**DEVELOPMENT REVIEW BOARD MEETING  
AUGUST 10, 2020  
6:30 PM**

**DEVELOPMENT REVIEW BOARD  
RESOLUTION NO. 380**

Exhibit A1  
Staff Report  
Frog Pond Ridge 71-Lot Single-Family Subdivision

Development Review Board Panel 'A'  
Quasi-Judicial Public Hearing

Please: Jul 01, 2020 - 8:28am dan.helen L:\Project\1940019489\CADD\DWG\P\19489P200.dwg Layout Name: P2.00

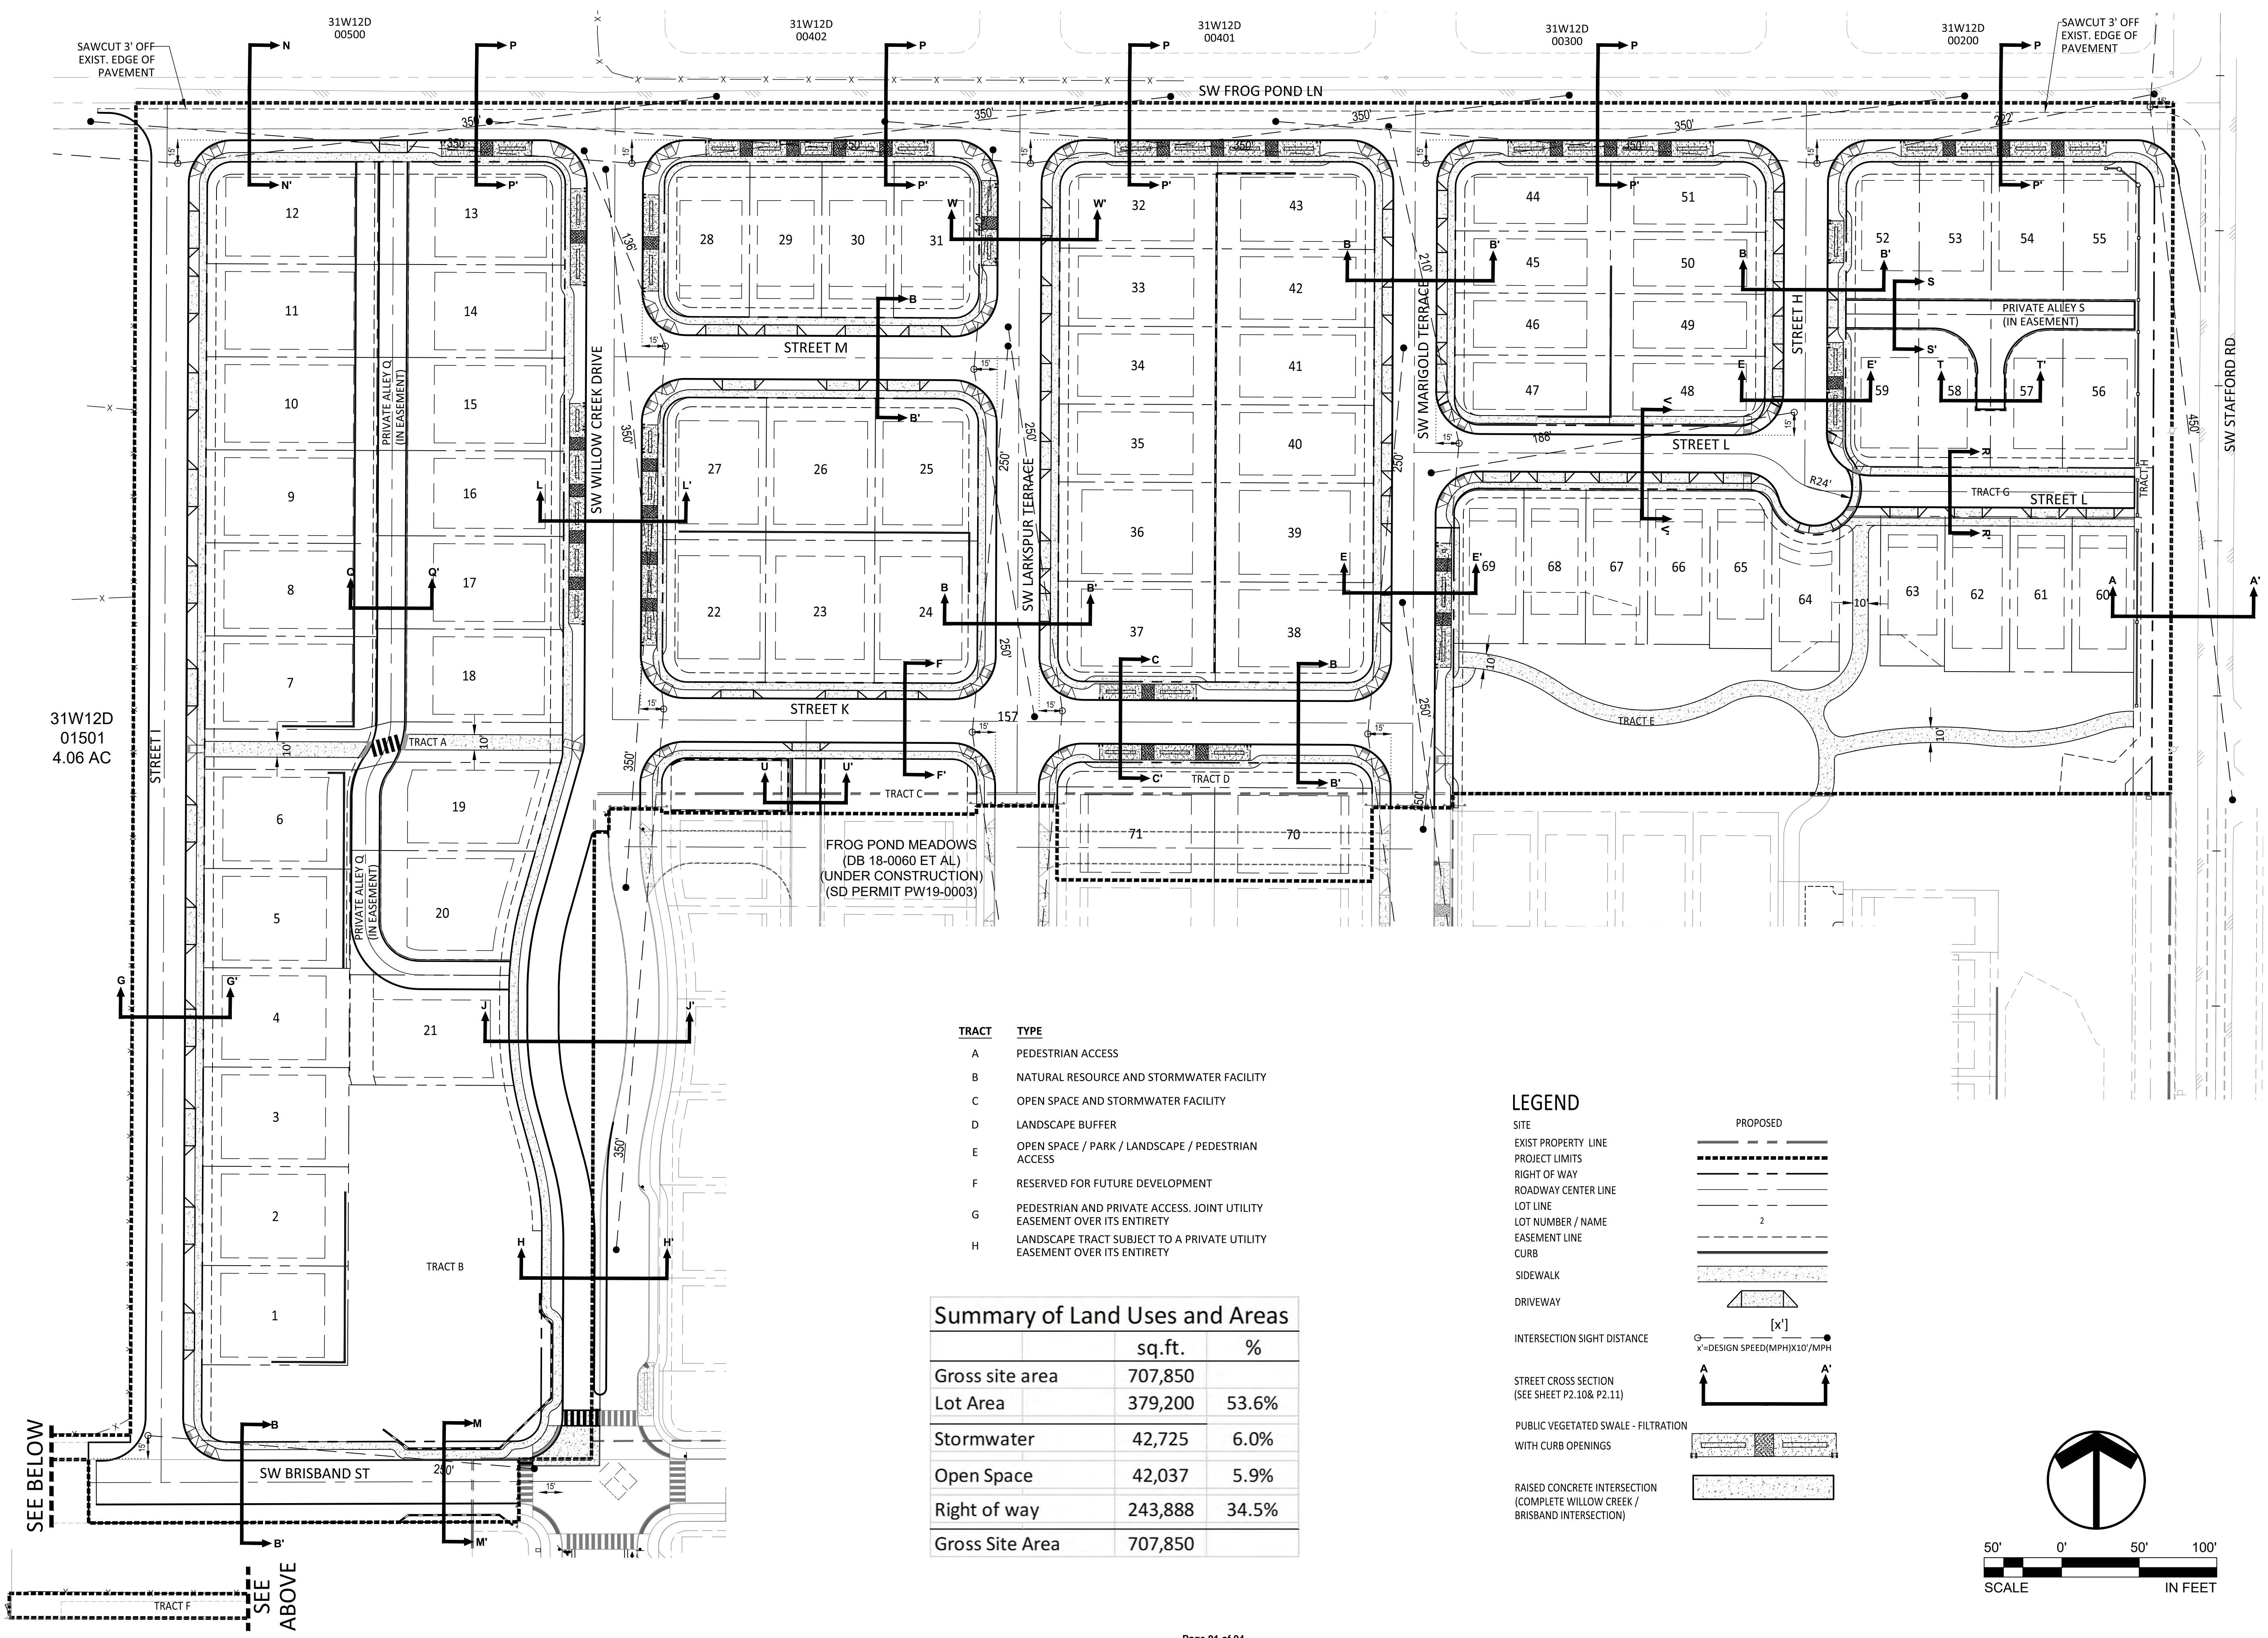
- C. *Verify that reducing the full ROW build out width from 52 feet to 42 feet to minimize SROZ impacts associated with the SW Brisband Street crossing is acceptable to Engineering; include the street cross section callout M-M on SW Brisband Street on Sheet P2.00 (Sections 4.139.06 (.03) and 4.177 (.02) B.)*

1. *Sheet P1.00 – Remove background from labels for Frog Pond Lane and 31W12D00401*
2. *Sheets P2.00 and P3.00:*
  - i. *Clarify that the alley access from SW Willow Creek Drive is RI/RO only; verify with TVFR that this is acceptable for emergency service provision*
  - ii. *Remove alley access to Lots 29-31 from Frog Pond Lane to reduce driveway cuts on the road consistent with the Frog Pond West Master Plan (Section 4.177 (.09))*
  - iii. *Indicate how the pedestrian path crossing of the alley (in Tract A) will be defined for safety; verify that the grade change at this crossing is ADA compliant*
  - iv. *Add ADA ramp where pedestrian path ends at Street I*

C. *On Sheet P2.00 - Street cross section callout M-M is missing on SW Brisband Street*

**Response:** Sheet P2.00 has been updated to include callout M-M.

- Sheet P1.00 has been updated to remove the referenced labels.
  - Due to the location of the Willow Creek Dr median at the intersection of Private Alley Q and Willow Creek Drive, this access will be right-in/right out only and there will be no option for a left turn at this location. No revisions have been made to the plans.

- Lots 29-31 have been reoriented north-south to take access from Street M. This results in through-lots, which have been addressed in the narrative. See Sheet P3.00.

- The pedestrian crossing of Private Alley Q (in Tract A) is shown as being striped where it crosses Private Alley Q. See Sheet P2.00.
  - An ADA ramp has been added where the pedestrian path ends at Street I. See Sheet P2.00.

**Response:** The M-M street cross section has been added to Sheet P2.00.

**P2.10**

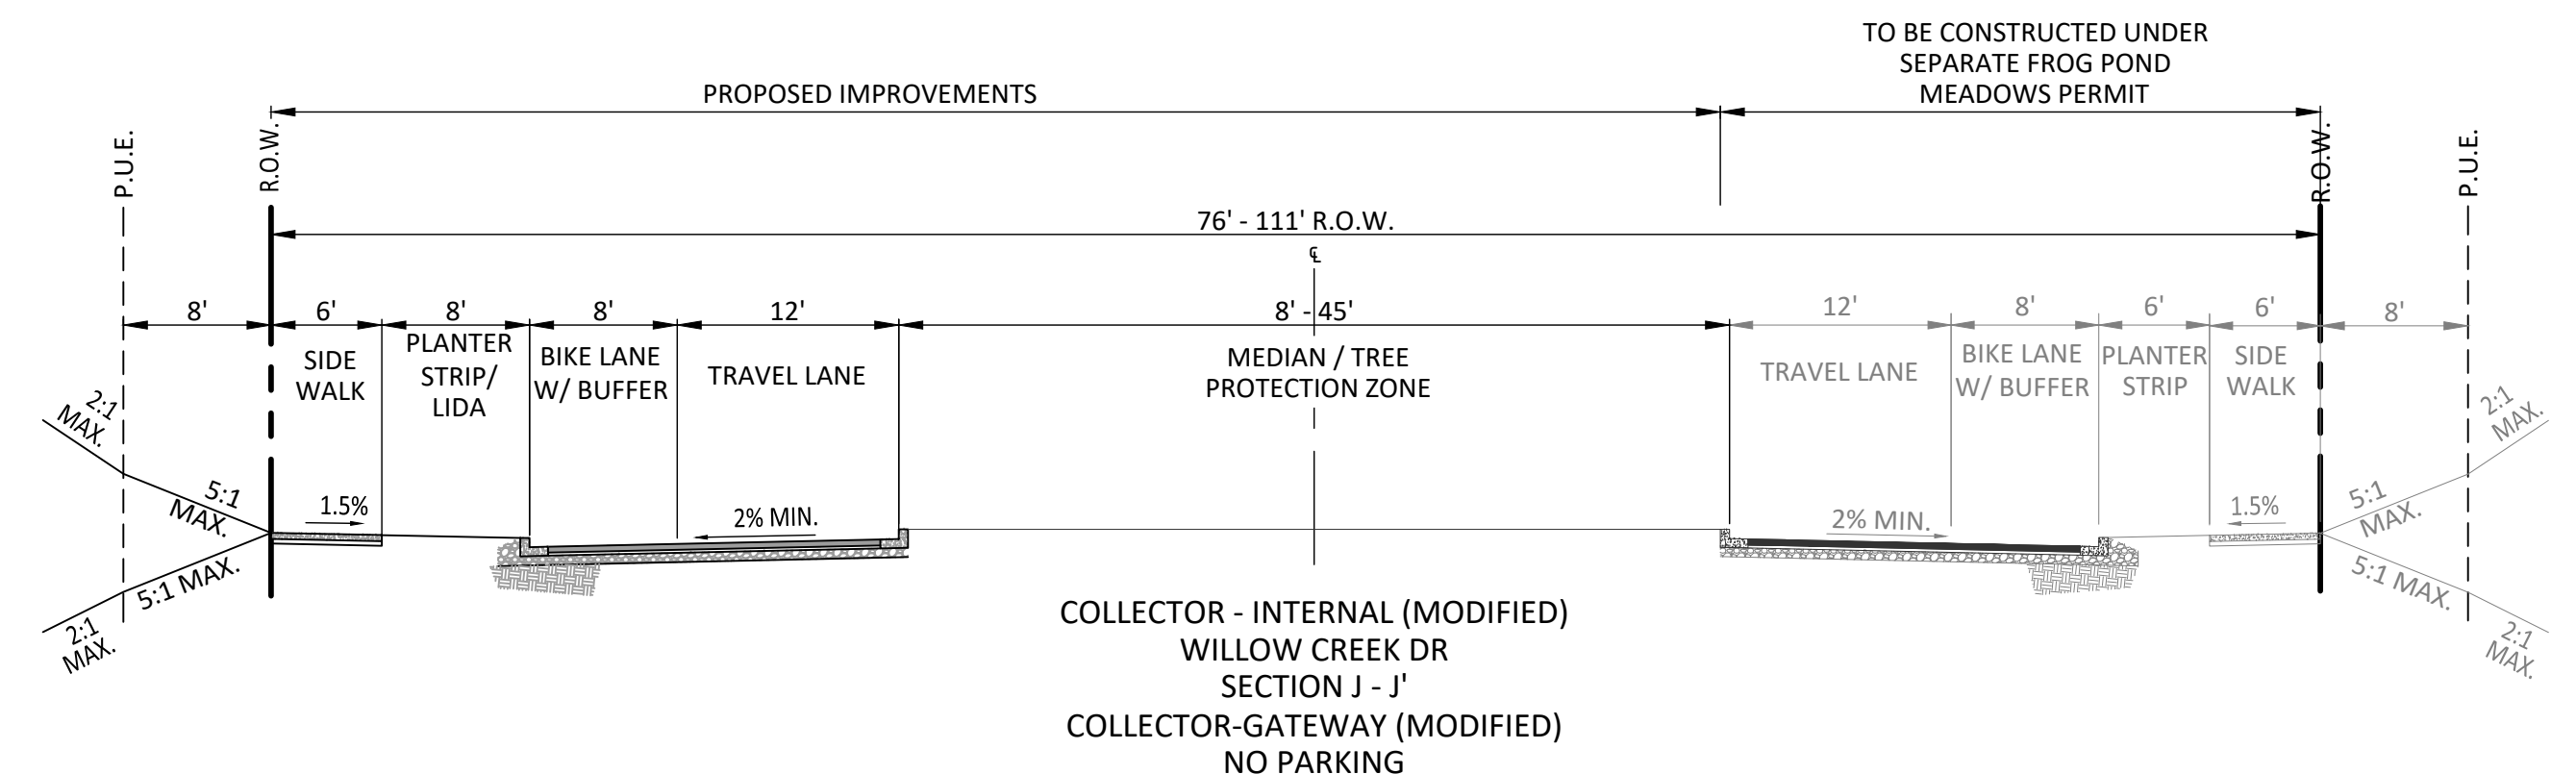
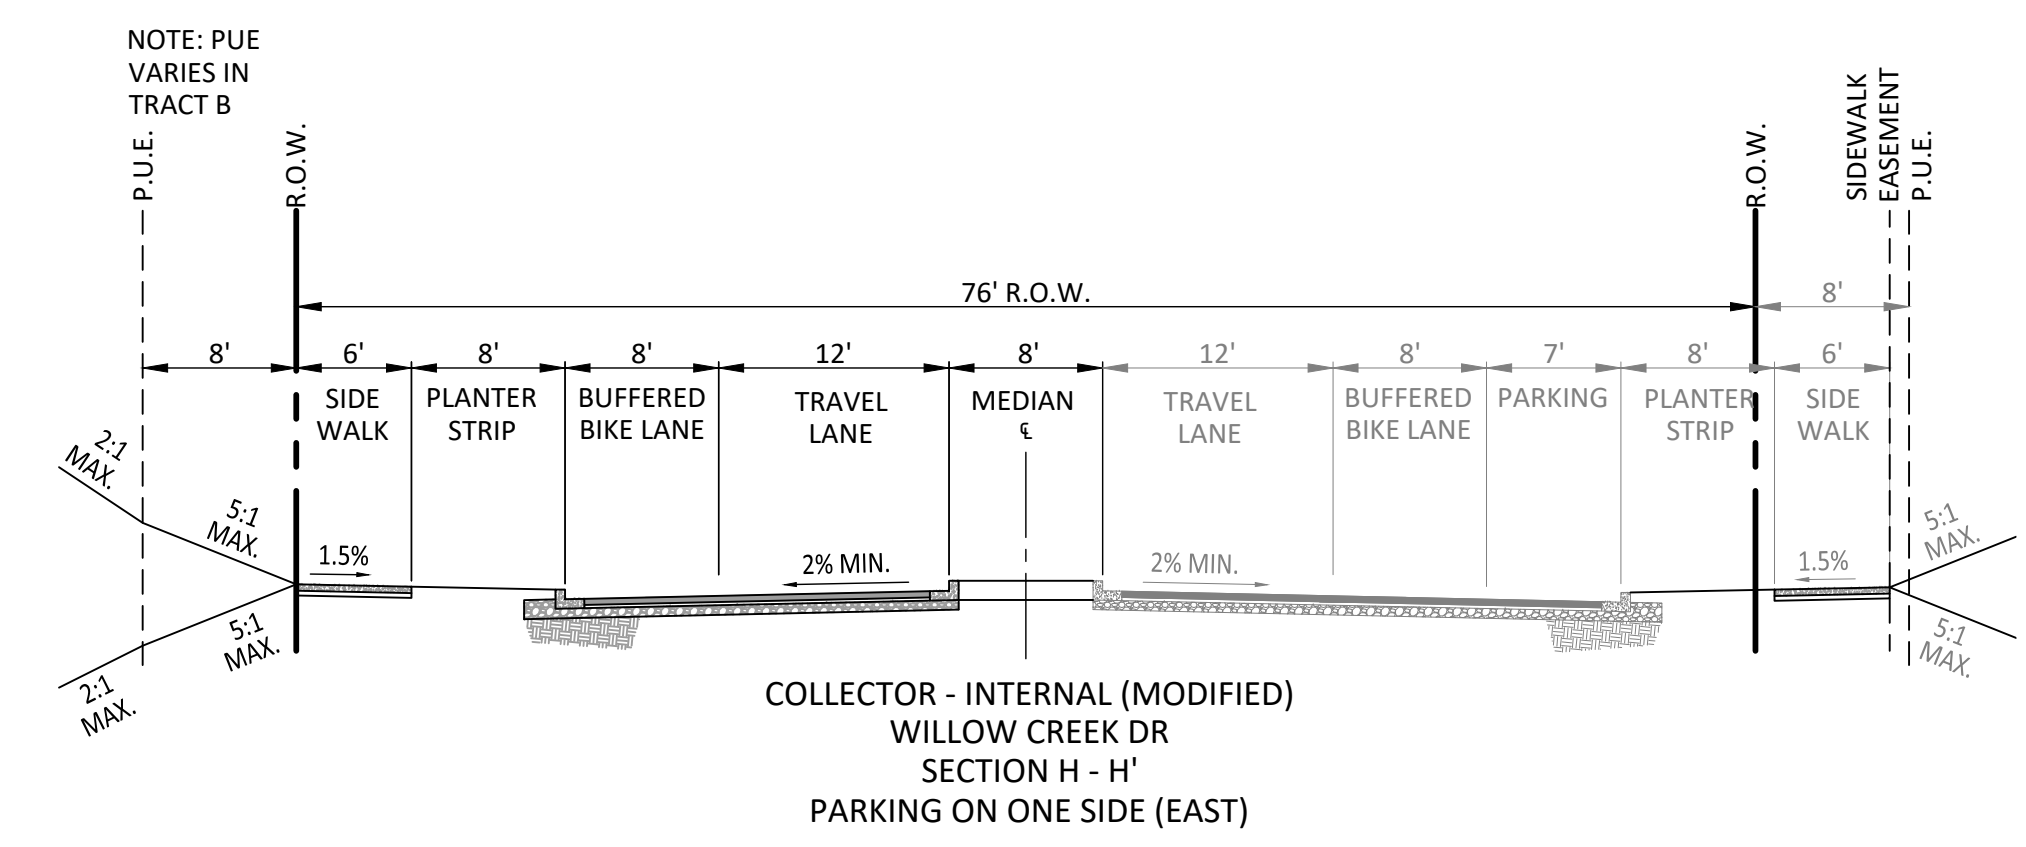
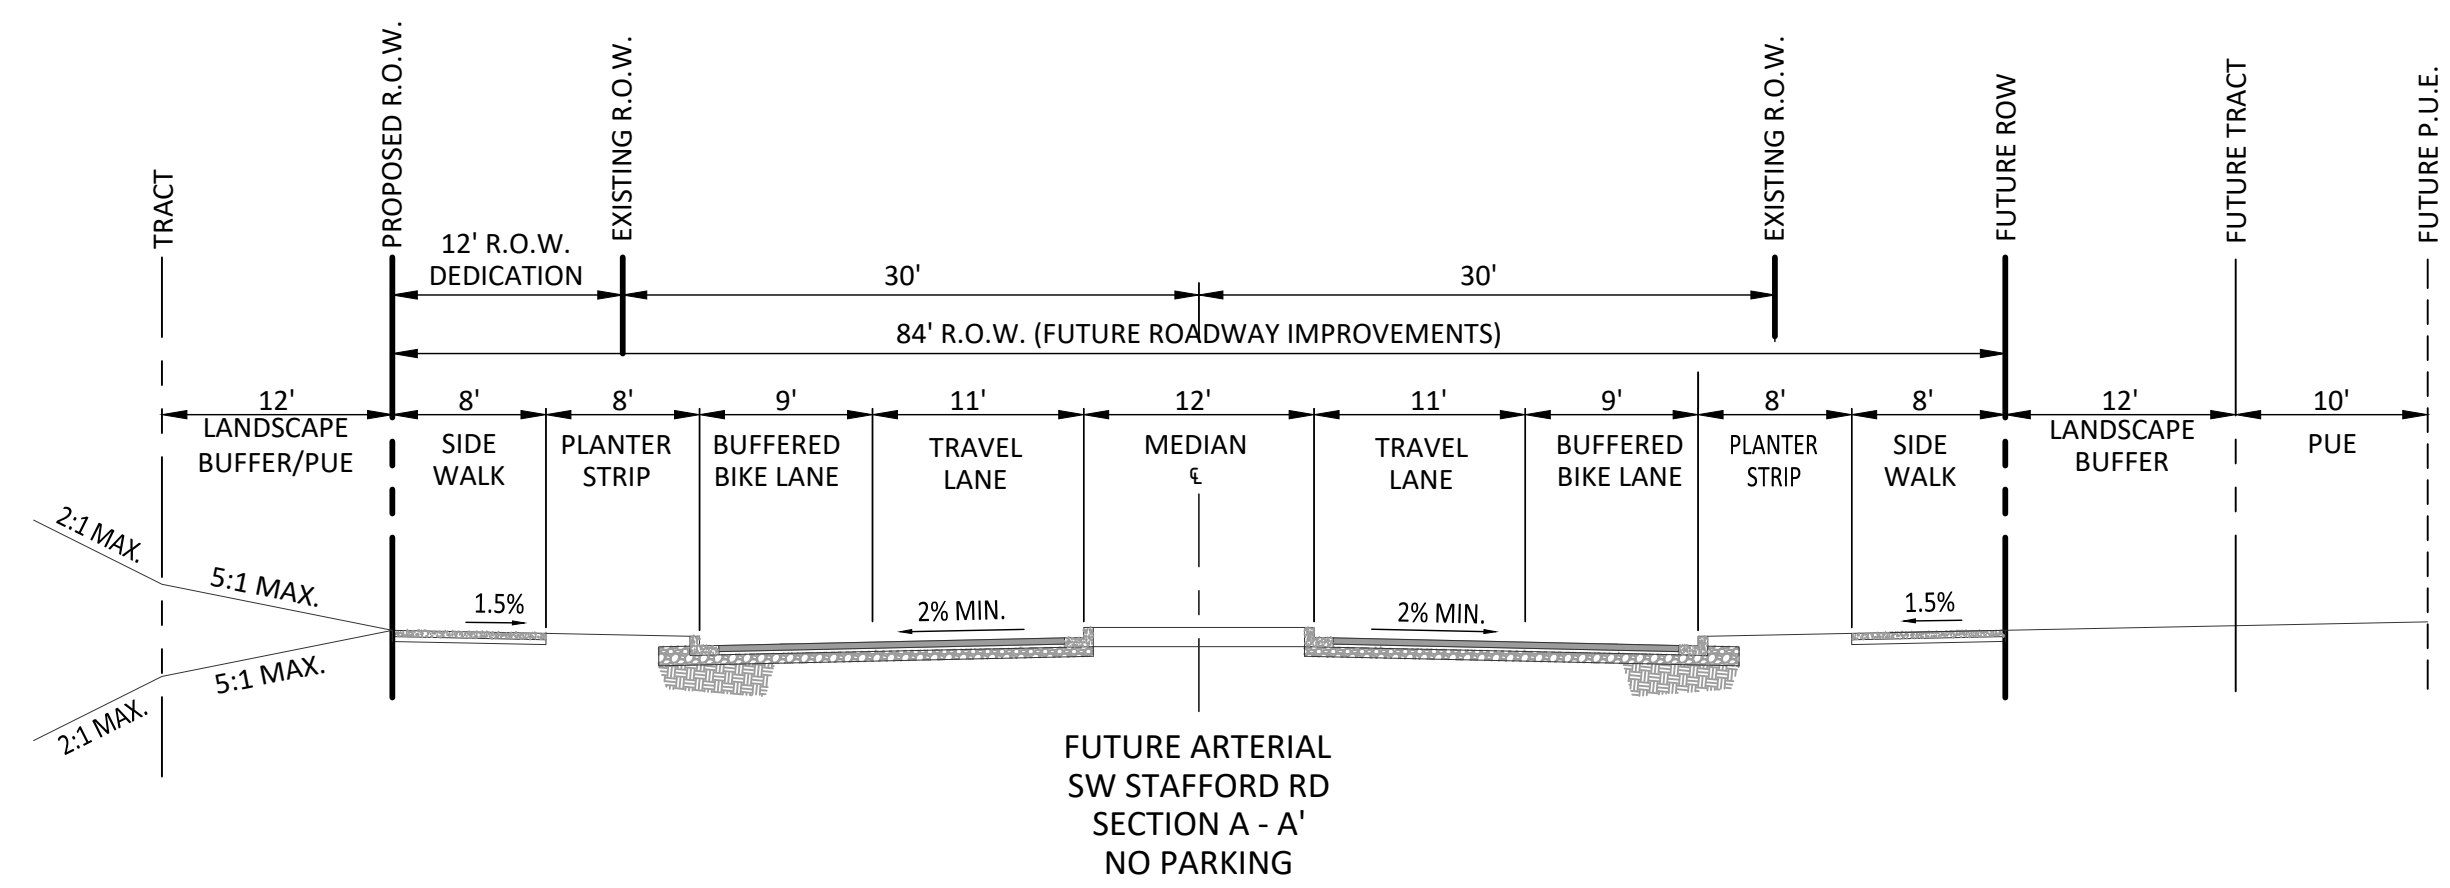
**D48.** The proposed street cross-sections (as shown on Sheets P2.10 and P2.11) comply with the street classifications and cross-sections identified in the Frog Pond West Master Plan with the exceptions noted in Finding D38 (see Exhibits C1 and C2). The SW Stafford Road and SW Willow Creek Drive cross-sections include buffered bike lanes. Bikes will share the vehicular lane with vehicles in the local streets.

**Response:** Street K narrows slightly west of SW Larkspur Terrace to allow additional area for stormwater treatment within Tract C and to align the southern sidewalk with the walkway within Tract A. The narrowing is accomplished by reducing the planter strip from 7 ft. to 5.5 ft. See Sheet P2.10 for details. This information has been added to the narrative. See page 48.
